# **Safety Evaluation Report**

related to the construction of the  
**Clinch River Breeder Reactor Plant**

Docket No. 50-537

**U.S. Nuclear Regulatory  
Commission**

Figure 2.4 Cumulative population distribution (1990)

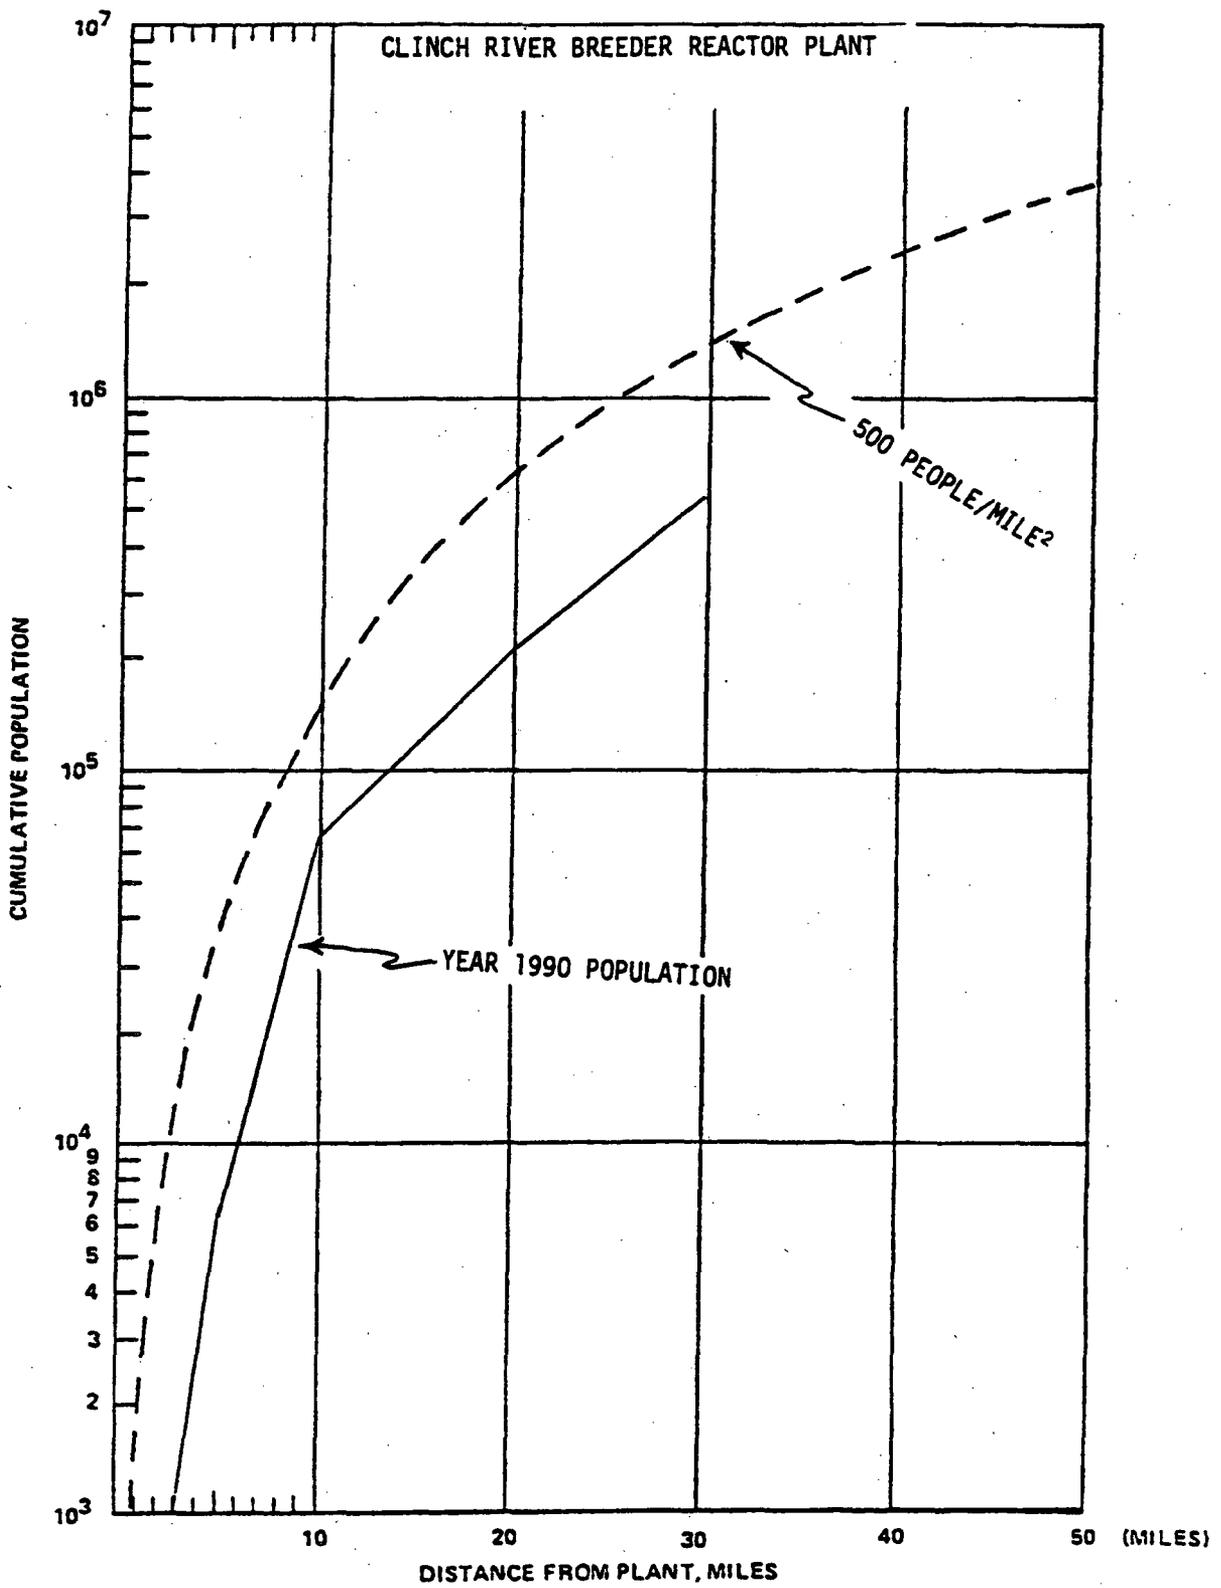
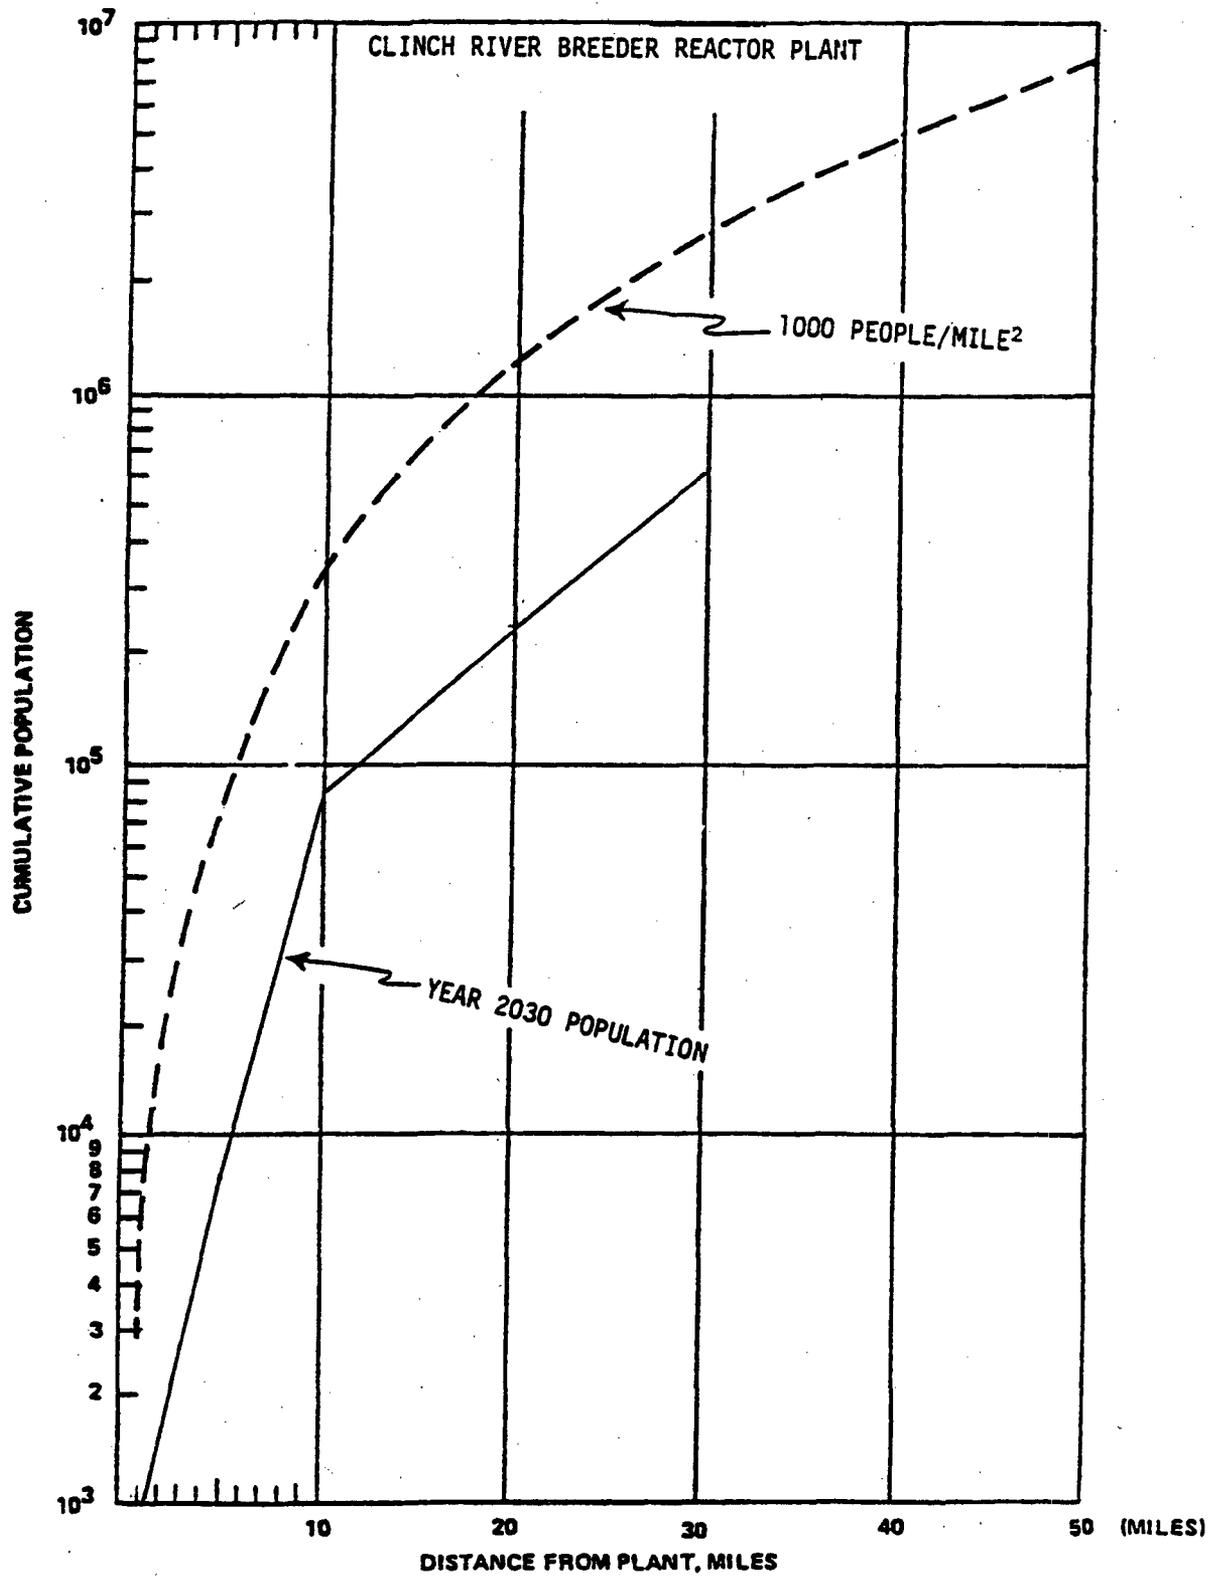
The staff compared the projected population density in the CRBRP site vicinity with the criteria given in RG 4.7 and Section 2.1.3. The resident plus weighted transient population density within 30 mi of the site at the projected time of plant startup (taken to be year 1990) was compared with a density of 500 persons per square mile. Figure 2.4 shows the 1990 population as a function of distance compared with a site having a uniform density of 500 persons per square mile. Similarly, the resident plus weighted transient population density within 30 mi of the site at projected end of plant life (taken to be year 2030) was compared with 1,000 persons per square mile. Figure 2.5 shows the projected year 2030 population as a function of distance compared with a site having a uniform

density of 1,000 persons per square mile. From the figures it can be seen that the population density in the vicinity of the CRBR site will be well within 500 persons per square mile at time of plant startup and well within 1,000 persons per square mile at end of plant life. The weighted transient population within 10 mi was estimated to be about 7,000 persons. This was added to the 52,000 residents in generating Figures 2.4 and 2.5. Most of the transients are employees of local industries and local school population. Since a significant number are probably also people who reside within 10 mi of the plant, the staff estimates that simply adding the weighted transients to the residents introduces some double counting and that the numbers are therefore conservative. The weighting factors used were based on annual average occupancy factors for the various groups.

Figure 4.12 Natural circulation coolant temperature for hot fuel pin

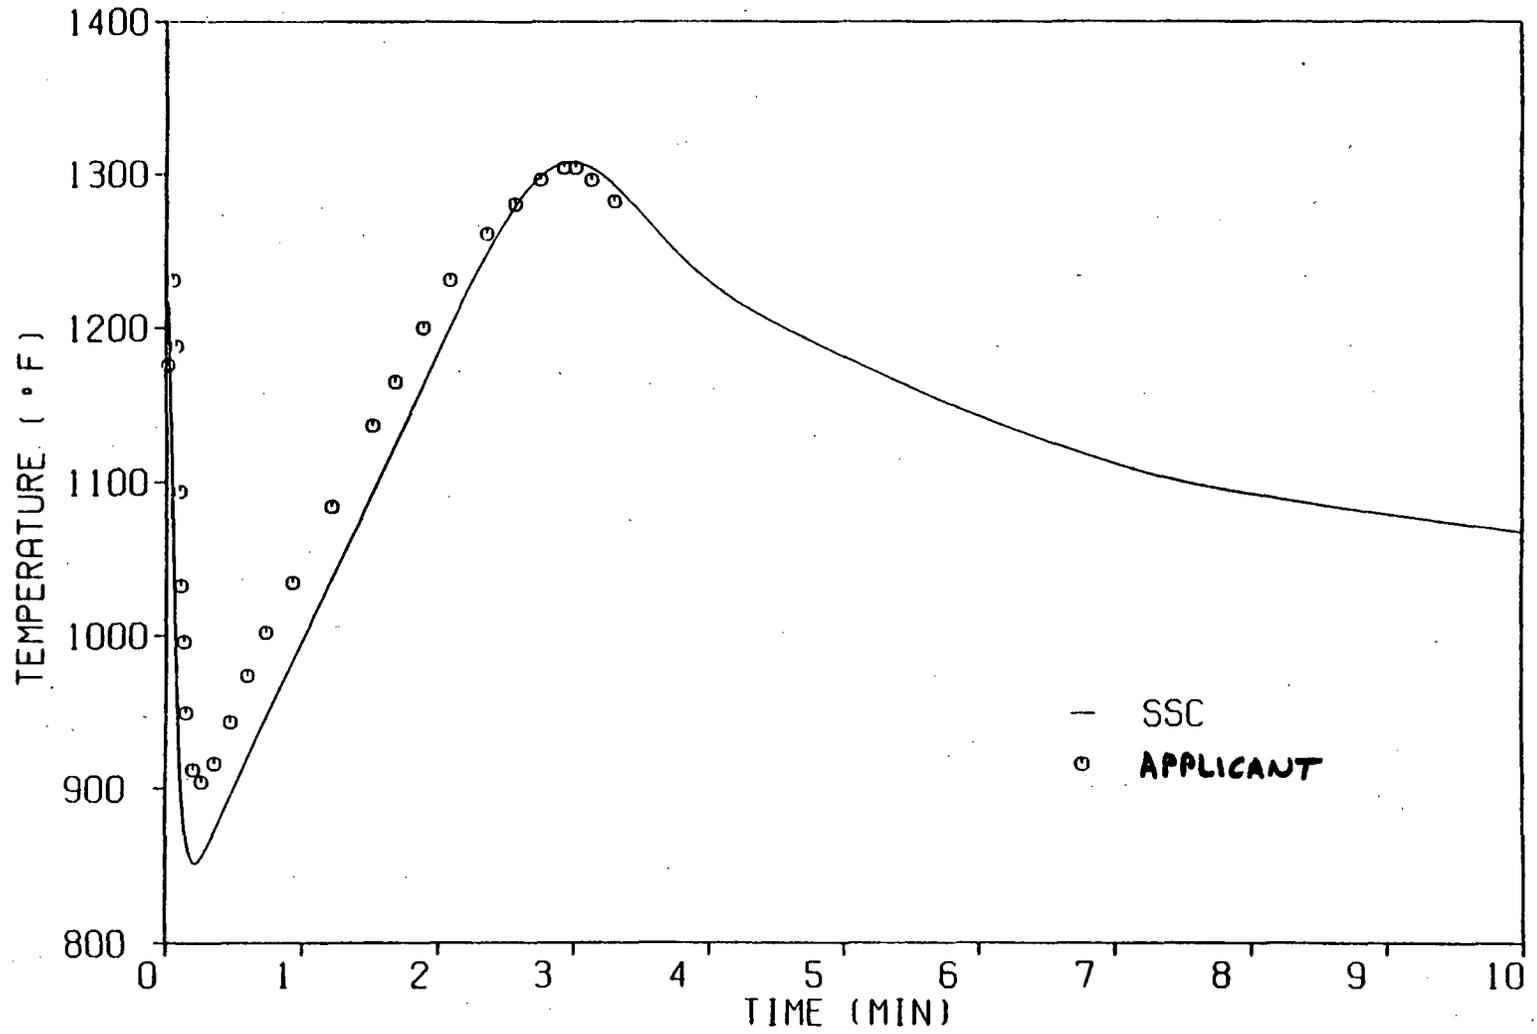
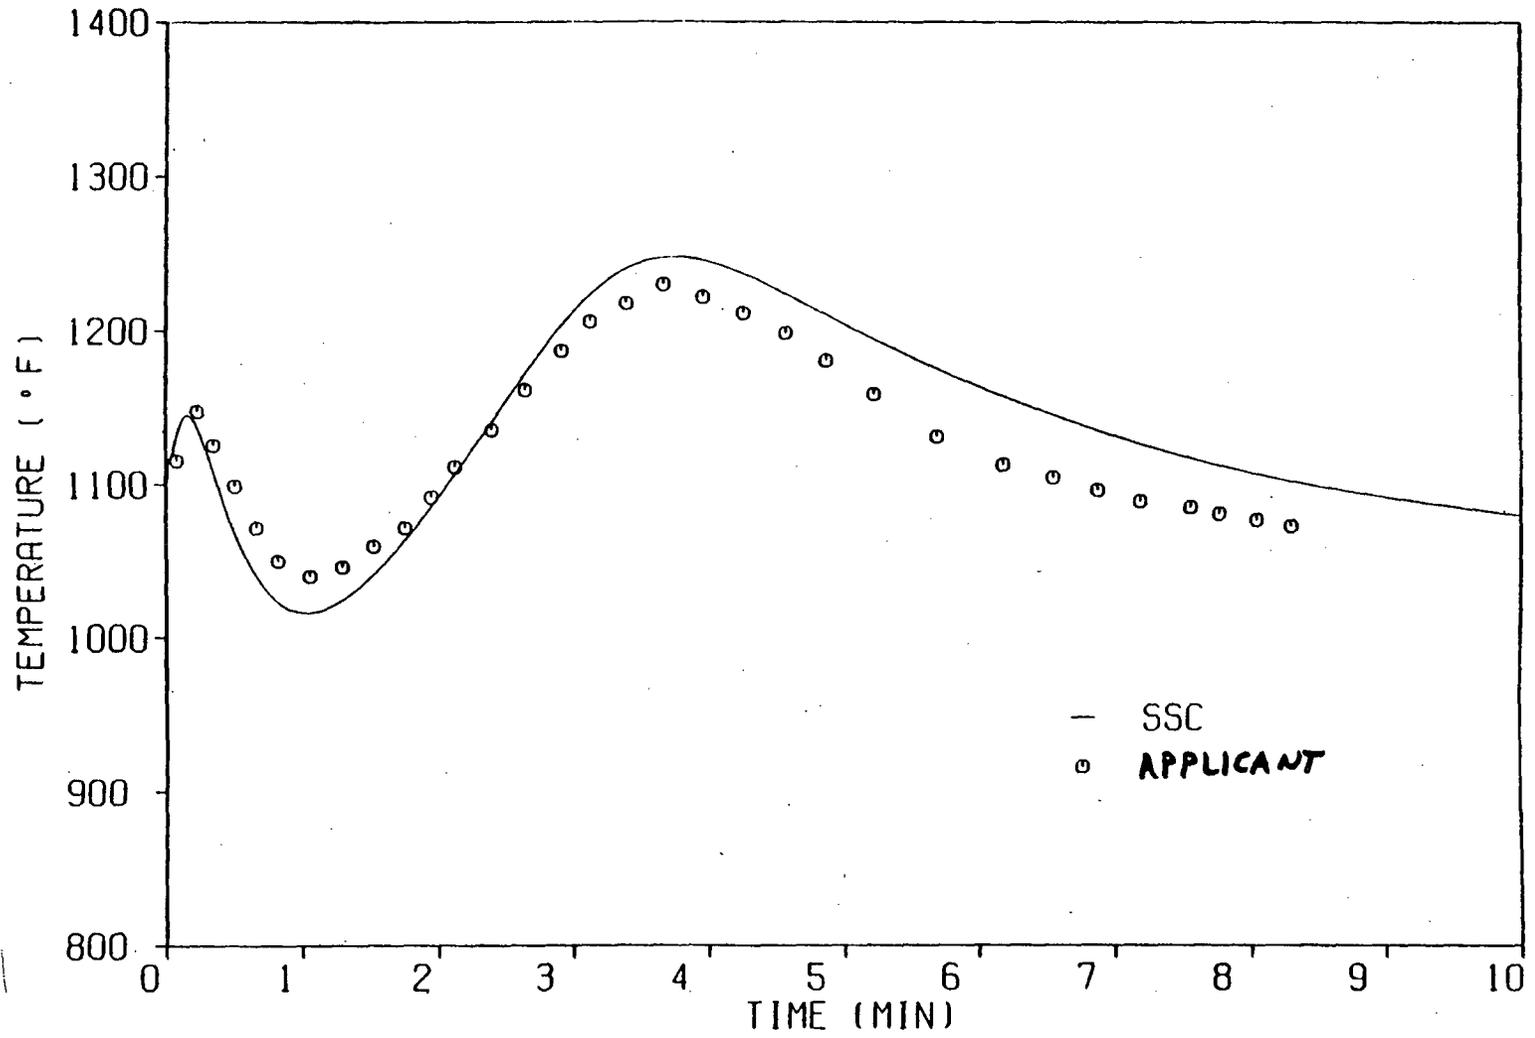
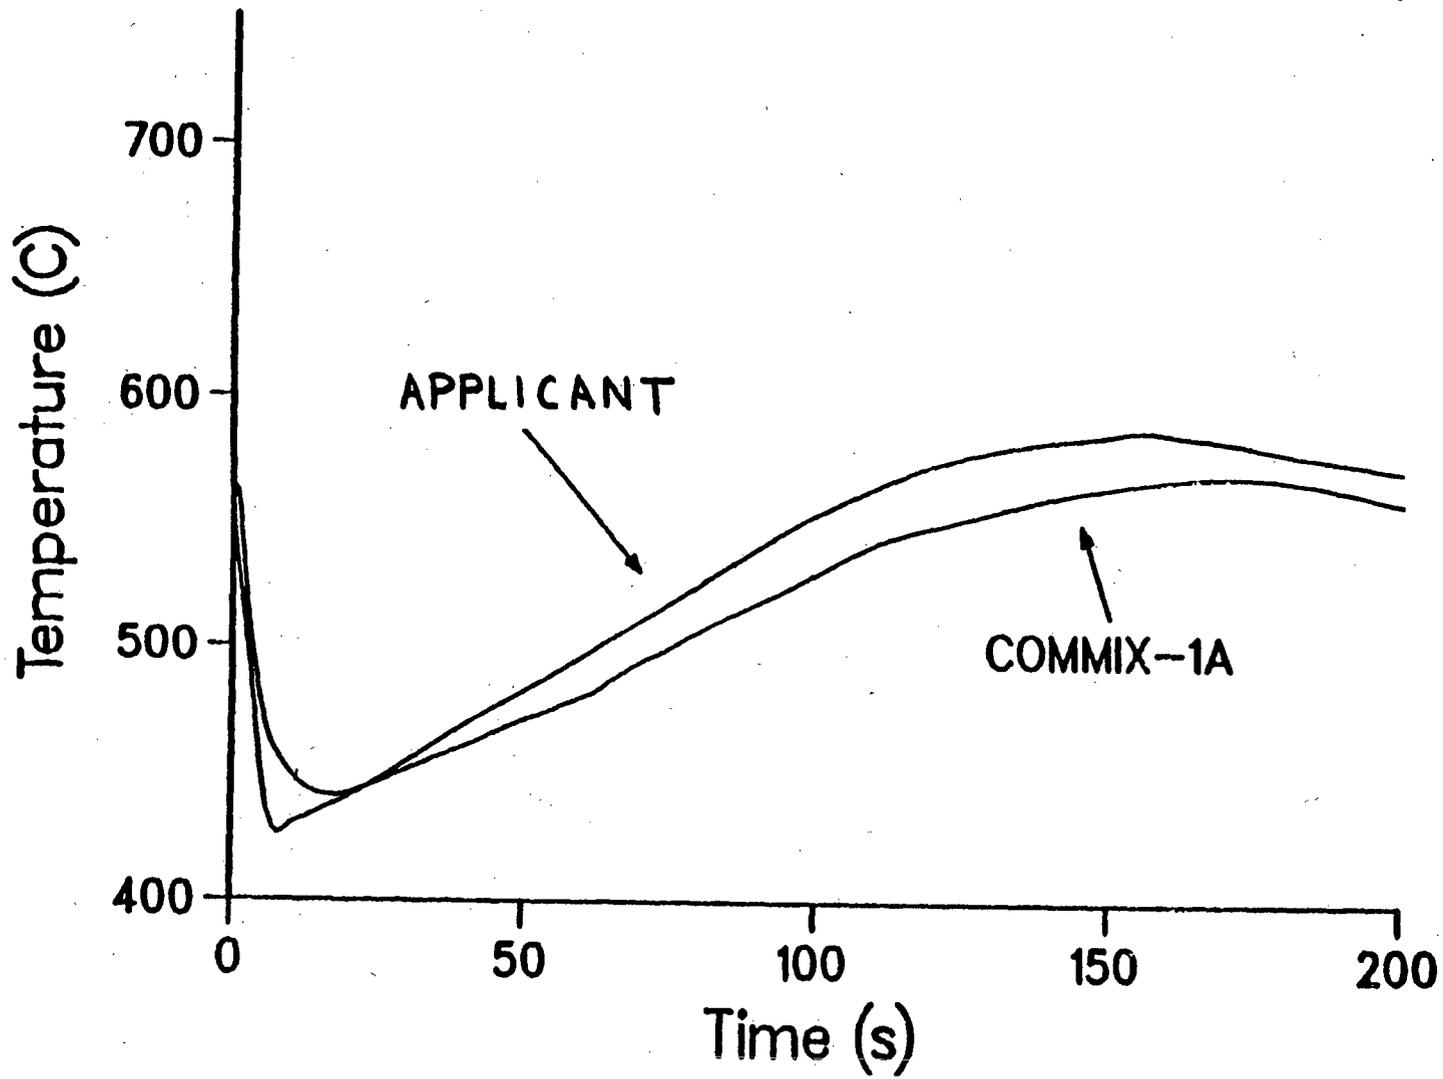
- (2) The calculated plant response to a scram to natural circulation indicated close agreement with similar values calculated by the applicants. Examples of the results and agreement are shown in Figures 4.12-4.14. In all cases the design criteria (no sodium boiling) were predicted to be met, the calculated trend of the transients were similar, and the applicants' results were close to or more conservative than the overcheck calculations.

Figure 4.15 Direct heat removal service design-basis accident--bulk upper plenum sodium temperature

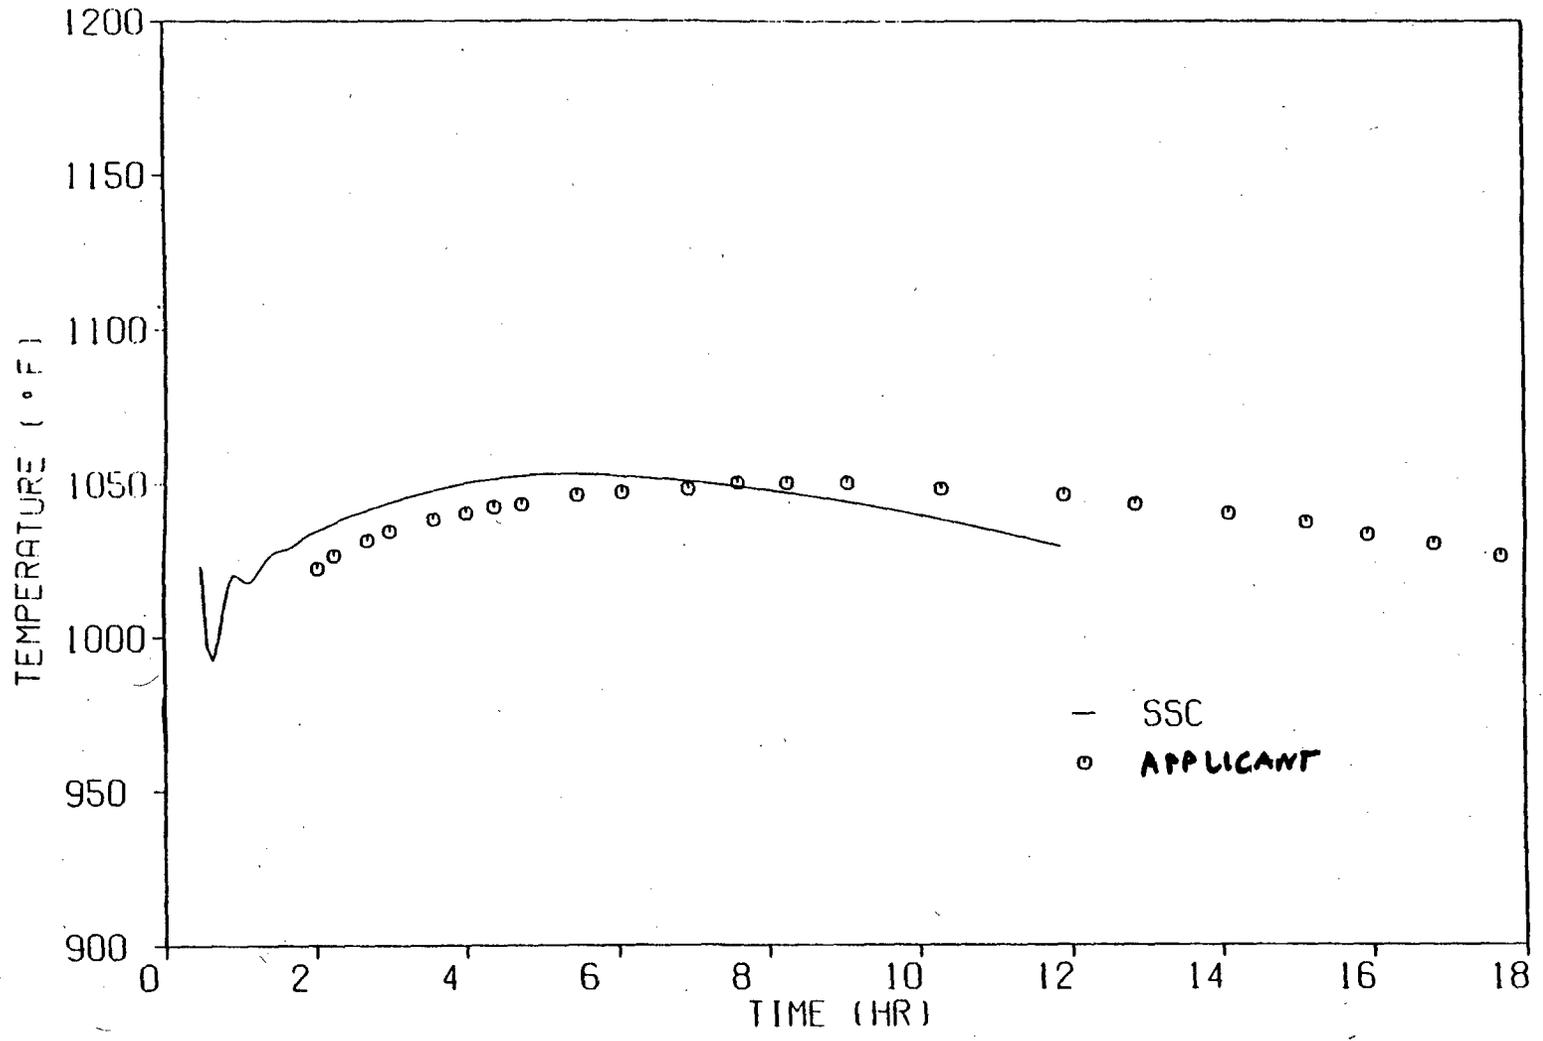
- (3) The calculated plant response to a scram to DHRS heat removal indicated close agreement with the applicants' prediction (see Figure 4.15). In addition, the sensitivity and correctness of the applicants' assumption on in-vessel flow short circuiting (amount of DHRS vessel inlet flow which goes directly out the DHRS outlet nozzle without mixing in vessel) were investigated. Figure 4.16 shows the results of the sensitivity investigation. The applicants assumed a 20% value for short circuiting in their analysis, and the effect of higher or lower short circuiting is shown in this figure.
